project **Stanwell New Projects Office**
Switchyard Road,
Stanwell, QLD, 4702

title **Section Details - Facade - Entries**

title Plan Details - Facade

1.2.4 DOCUMENT REVIEW The reviewer shall review the documents submitted by the contractor to ensure that they are complete and accurate. The reviewer shall also ensure that the documents are in accordance with the contract requirements. The reviewer shall provide a written report of the review to the contractor within the specified time frame.	
A Reviewed by Contractor	B Reviewed by Consultant
C Reviewed by Employer	D Reviewed by Architect
Normal Kesejahteraan Date: 17/12/2025	
 Inhabiti Inhabiti Australia Pty Ltd

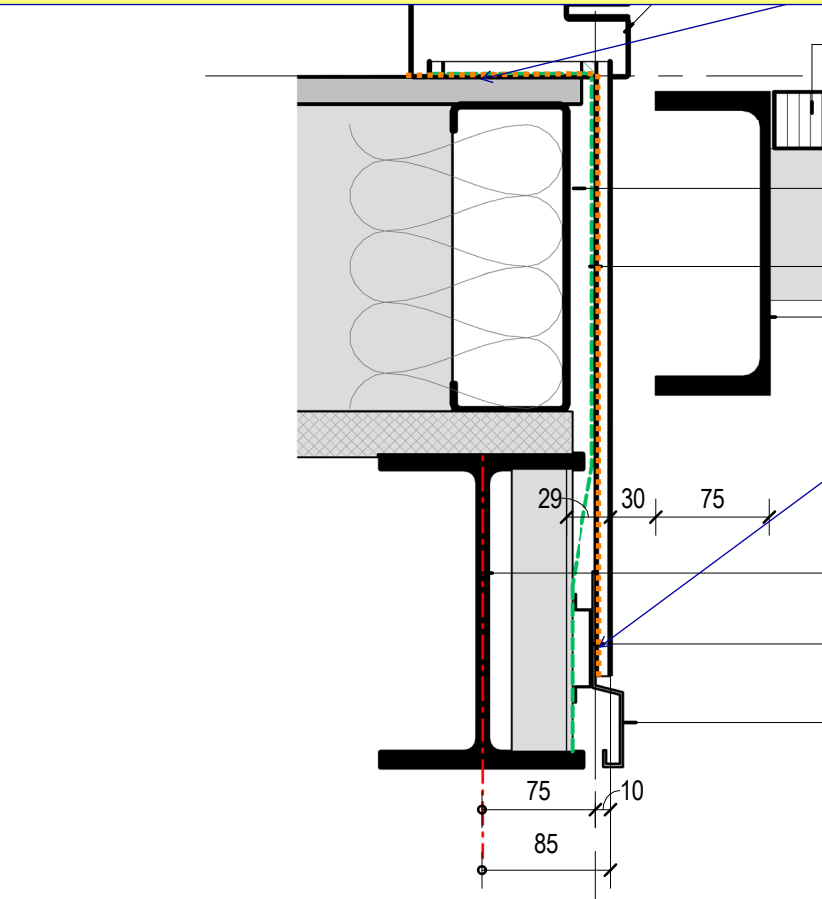
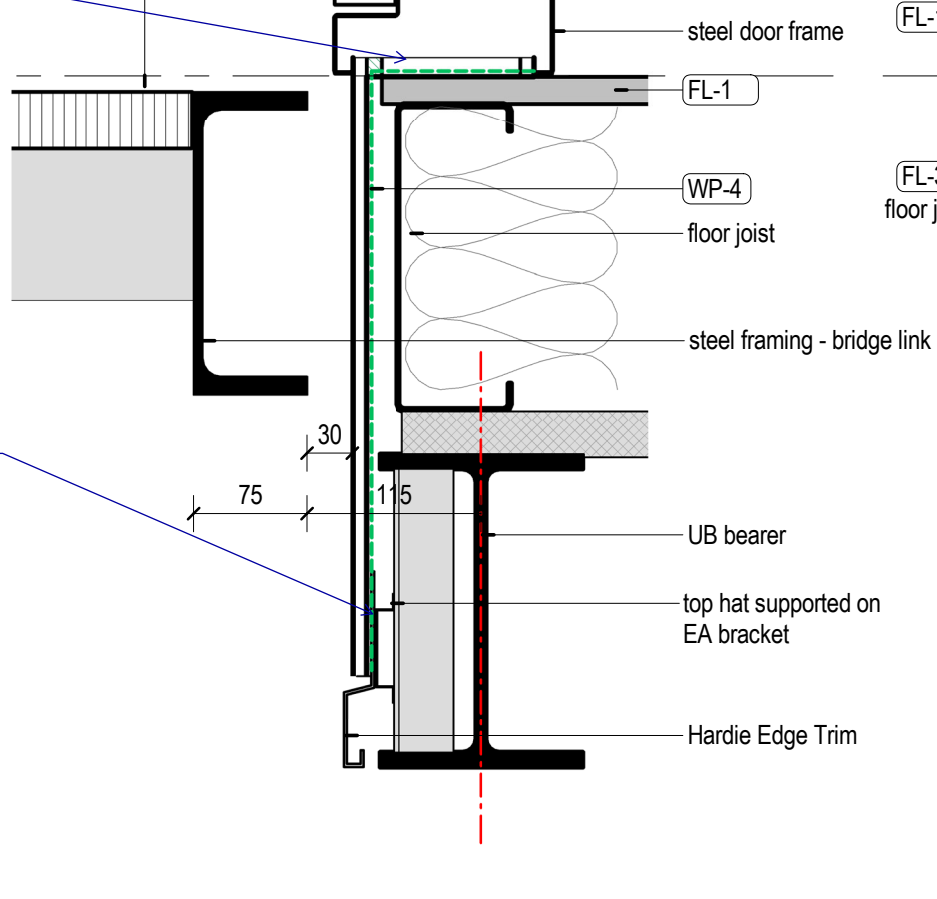
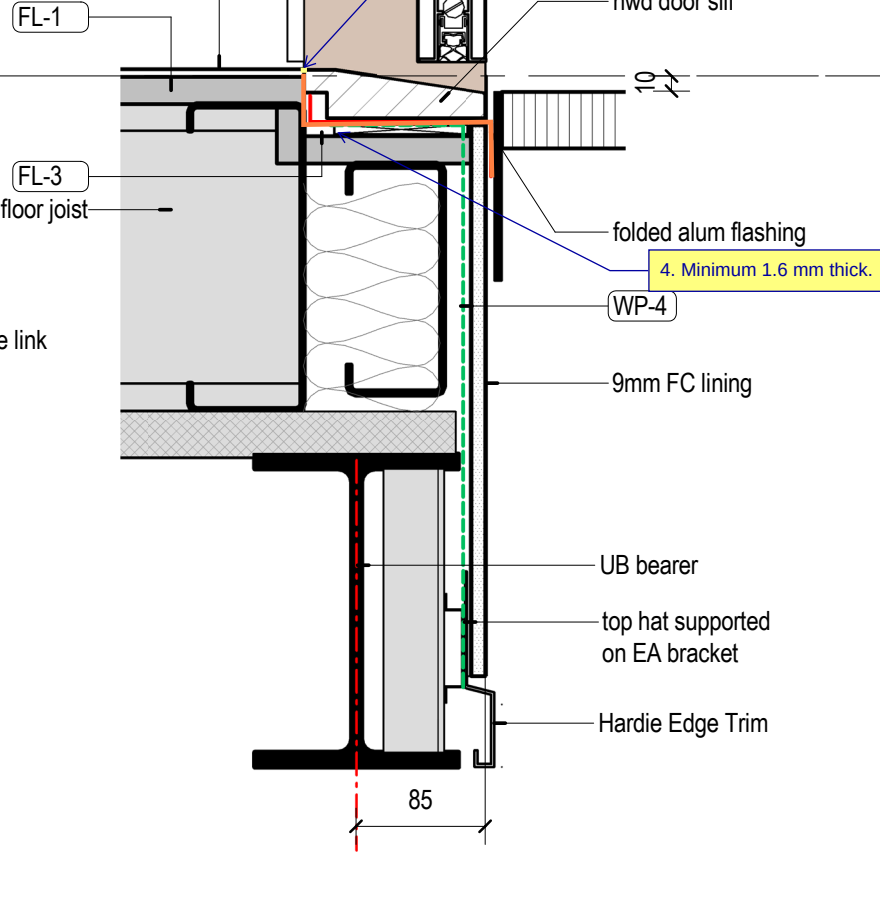
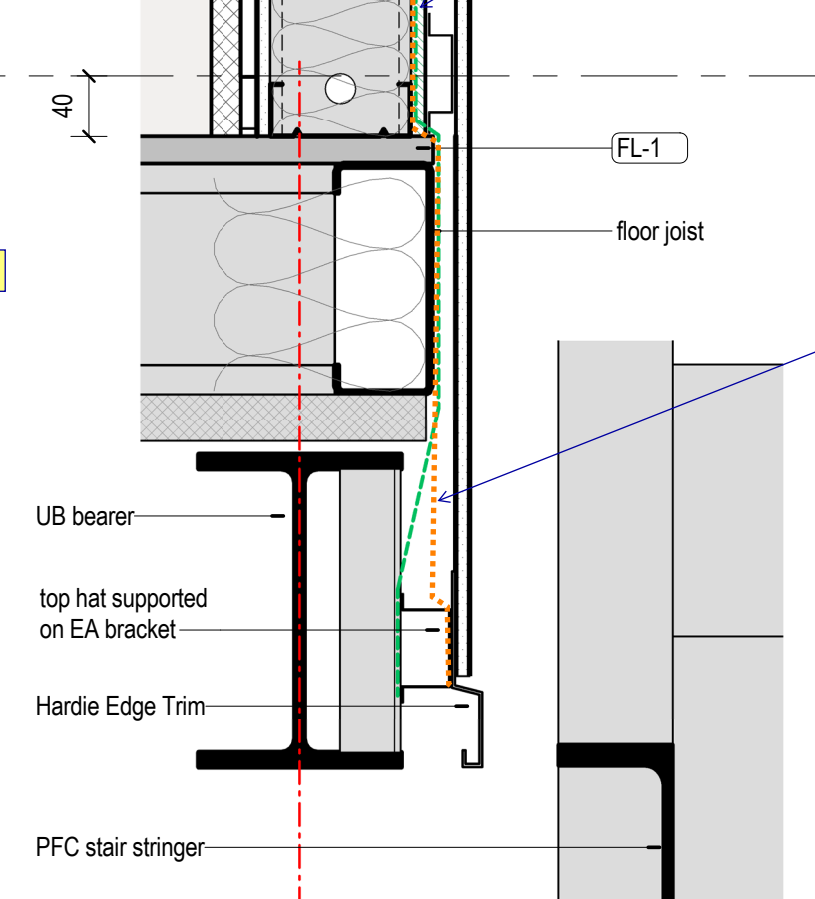
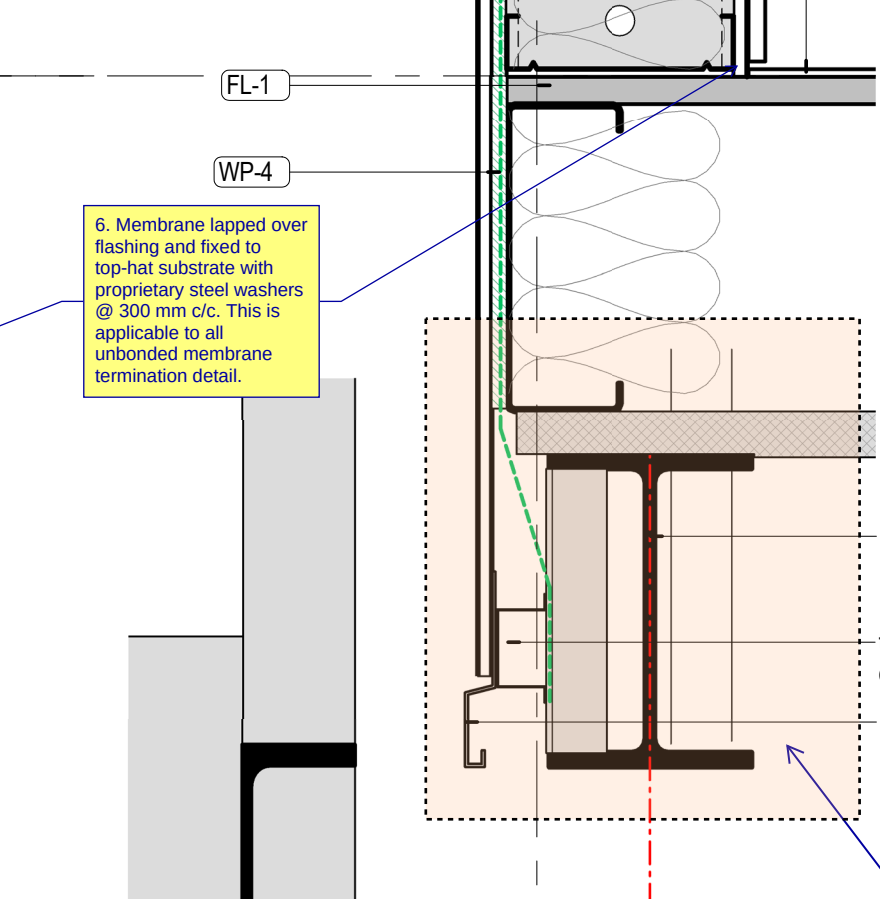
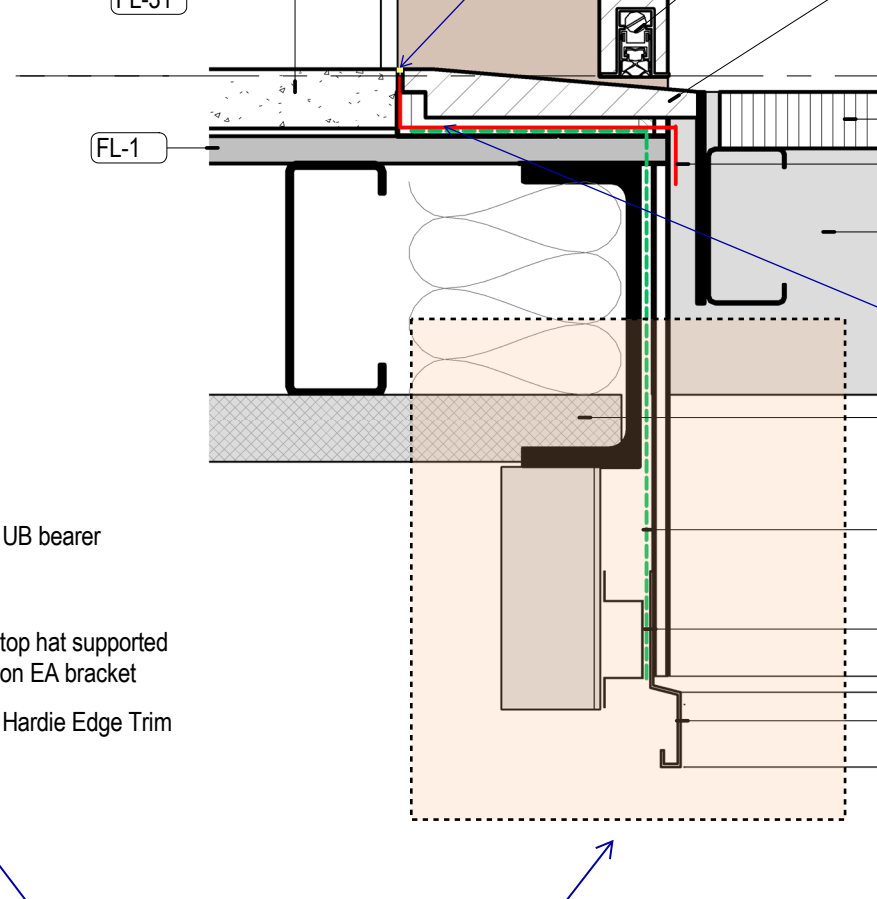
Notes:
1. All comments are applicable to similar details.
Membrane is shown in the architectural facade drawings below, however, specialised membranes are required at window reveals, including window sills, lap joints, and membrane terminations. Refer to the Inhabit F3P1 P60B. Where information is not available, liaise with the product supplier, architect, and facade consultant.

3. Glazing and its interface details need to be reviewed as part of the shop drawings for FP1.4 verification.
4. The Inhabit weatherproofing mark-ups on the architectural drawings are to be read in conjunction with the Inhabit F3P1 P60B.

5. The aluminium sill flashing shall be installed with end dams at each end and fully sealed at corners and at vertical steel post interfaces. The flashing shall be continuous and wrap around the steel posts. Junctions shall be verified by water hose testing.

6. For all screw installations between the timber/aluminium framed cladding and the substrate, apply a blob of sealant prior to installing the screw, and seal the screw heads afterwards. Stainless steel screw/anchors are to be used.

7. The following items shall be inspected and agreed during the first panel installation:
a. Lap over AM-2b with sill tape (at the top leg)
b. Weep holes within the system

c. Drainage within AM-2b

8 Aluminium flashing is to be installed with end dams at each end and fully sealed at the corners and vertical steel-post interfaces. The flashing must be continuous and wrap around the steel posts.

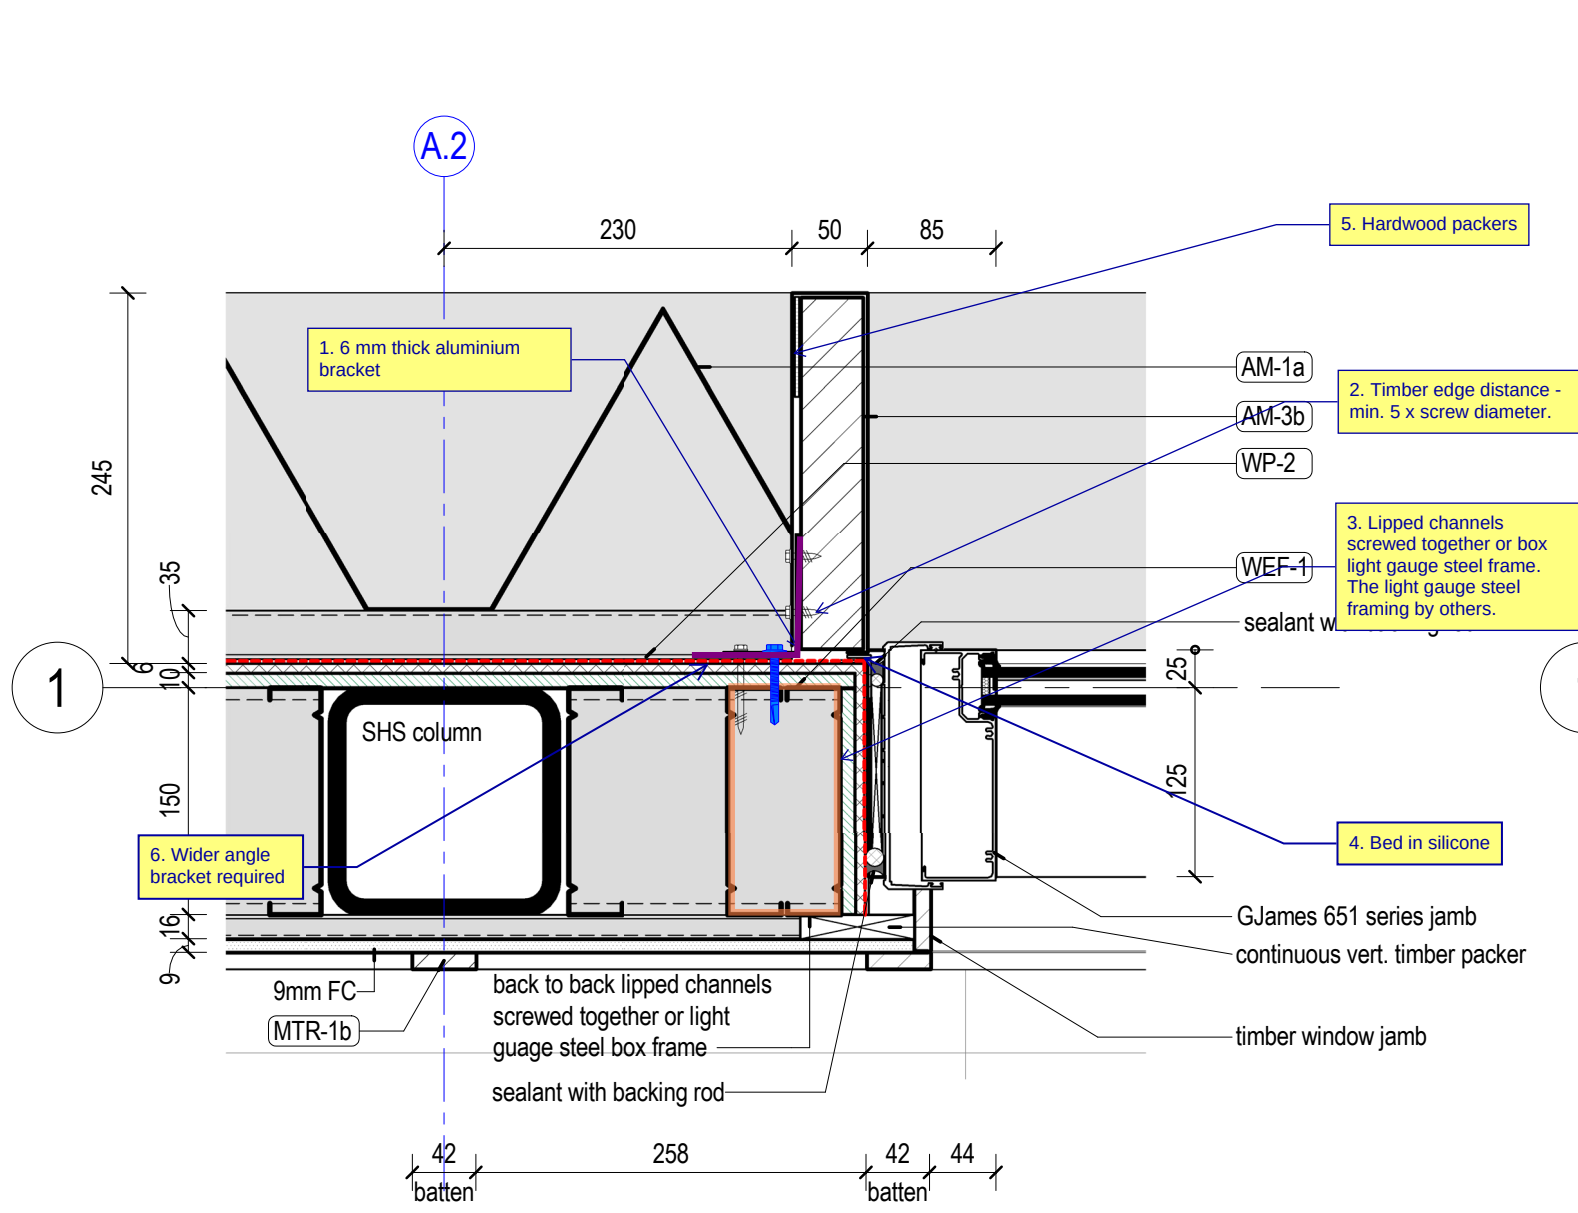
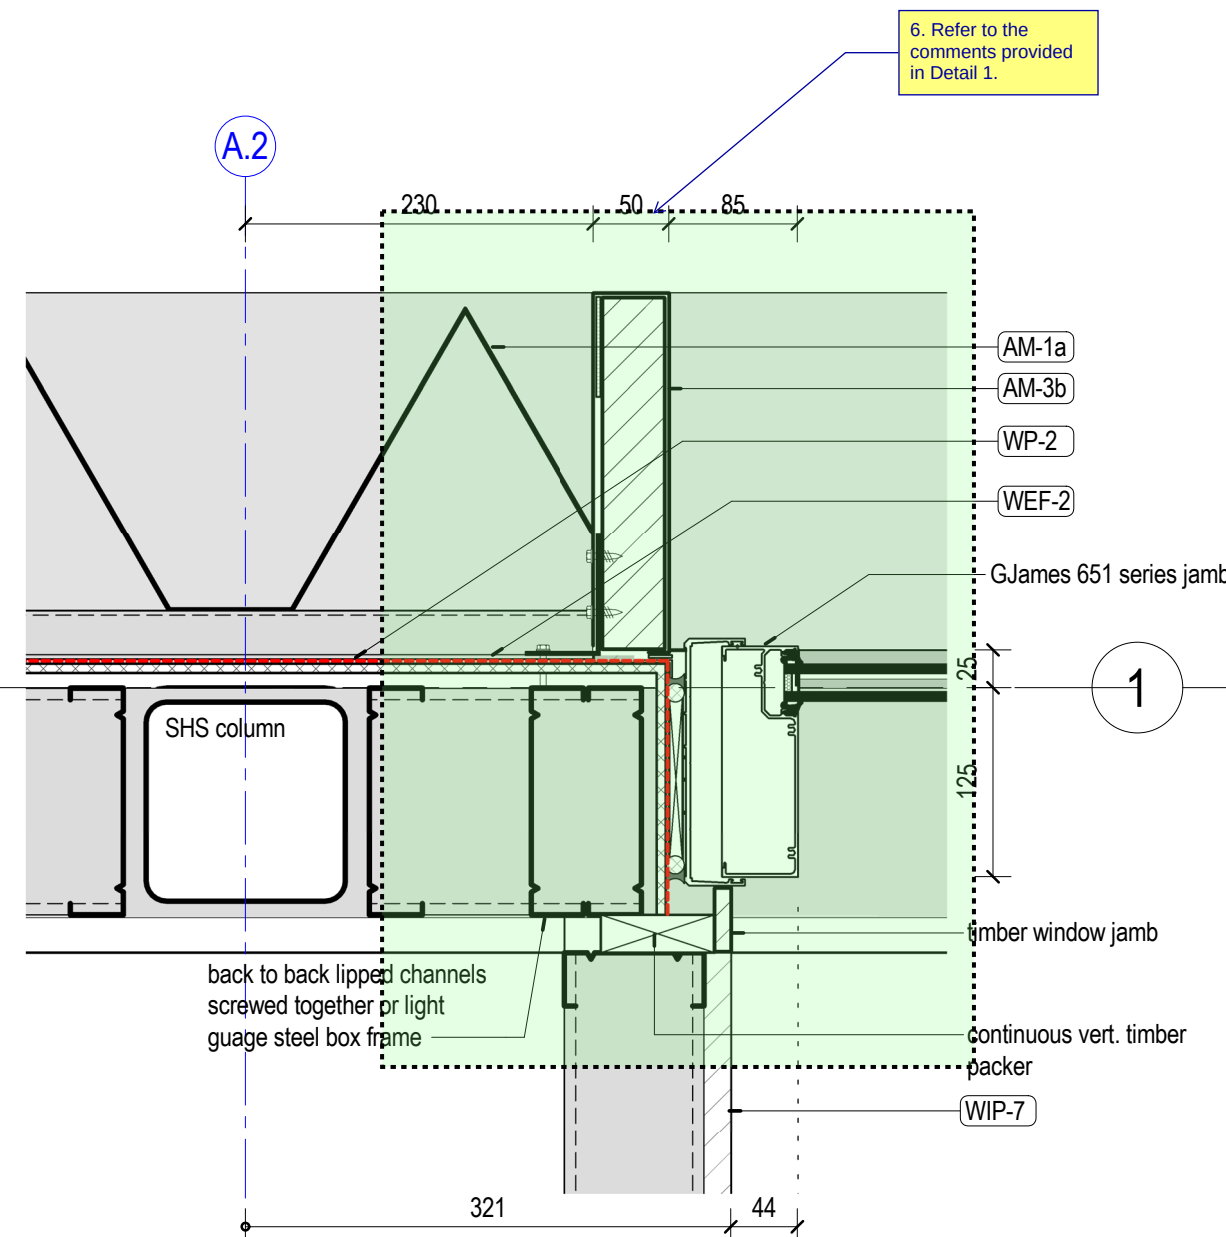
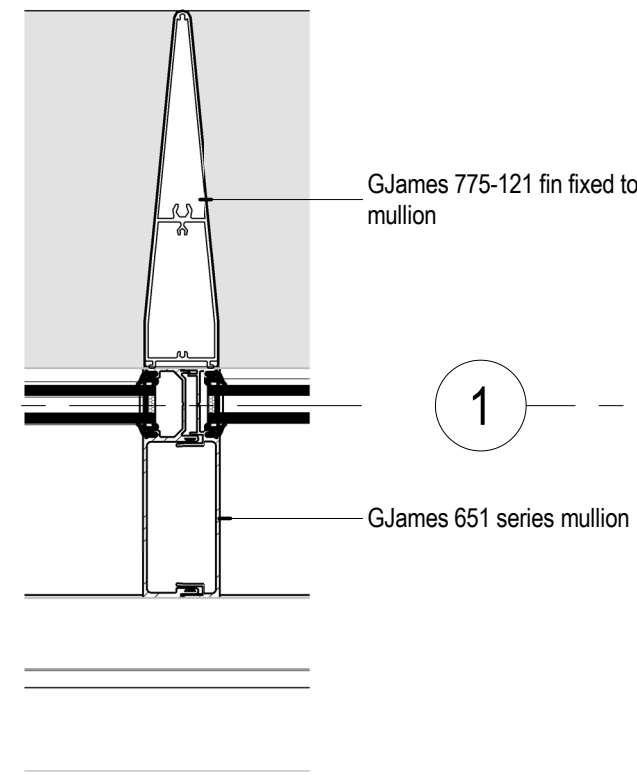
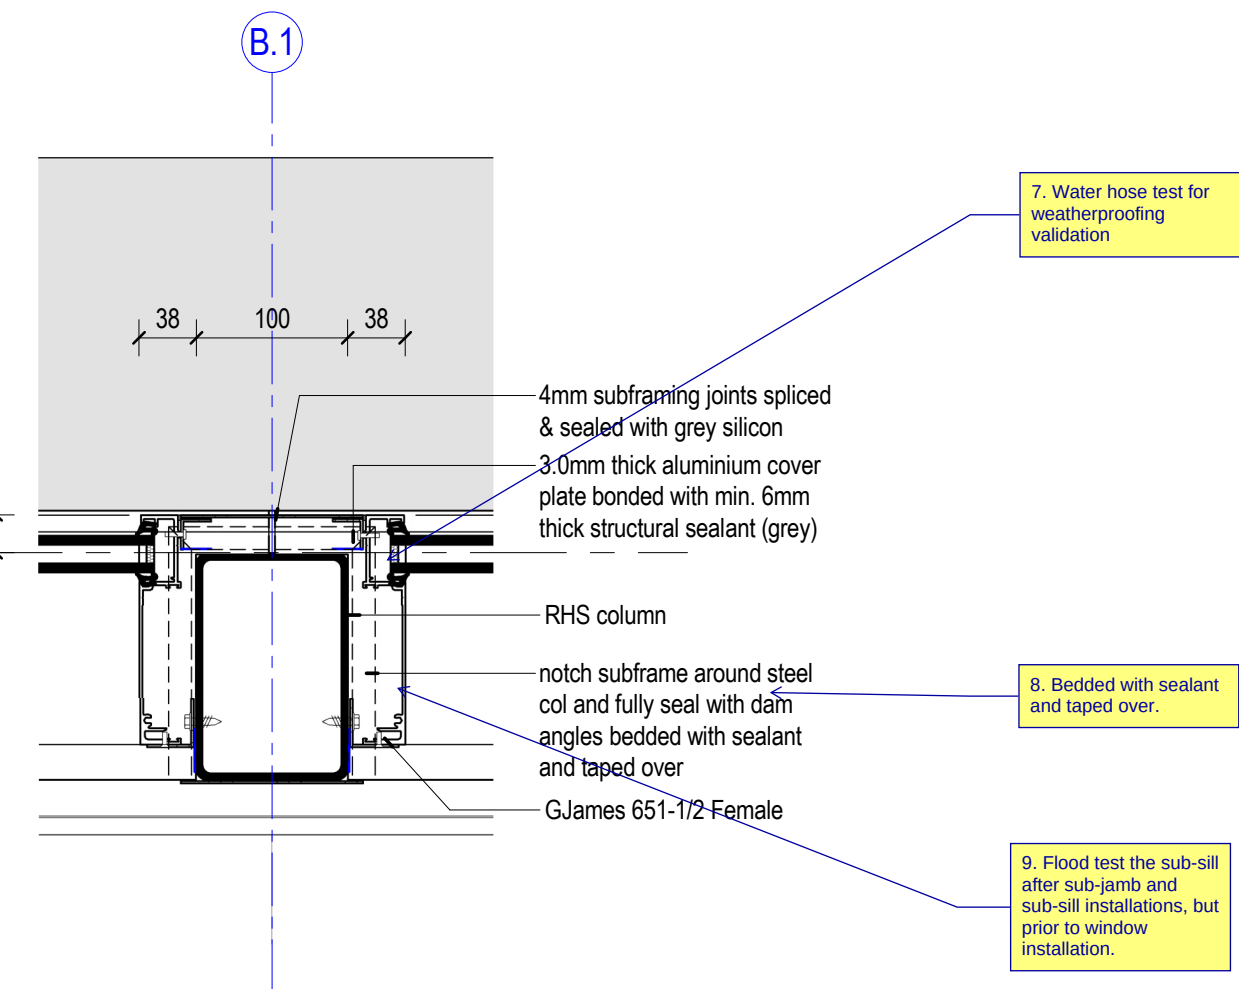
Notes:
1. All comments are applicable to similar details.
2. Membrane is shown in the architectural facade drawings below; however, specialised membranes are required at window reveals, including window sills, lap joints, and membrane terminations. Refer to the inhabit F3P1 PBD. Where information is not available, liaise with the product supplier, architect, and facade consultant.

3. Glazing and its interface details need to be reviewed as part of the shop drawings for FPI.4 verification.
4. The inhabit waterproofing mark-ups on the architectural drawings are to be read in conjunction with the inhabit F3P1 PBD.

5. The aluminium sill flashing shall be installed with end dams at each end and fully sealed at corners and at vertical steel post interfaces. The flashing shall be continuous and wrap around the steel posts. Junctions shall be verified by water hose testing.

6. For all screw installations between the timber/aluminium-framed cladding and the substrate, apply a blob of sealant prior to installing the screw, and seal the screw heads afterwards. Stainless steel screws/anchors are to be used.

7. The following items shall be respected and agreed during the first panel installation:
a. Lap over AM-2b with sill tape (at the top leg)
b. Weep holes within the system

c. Drainage within AM-2b
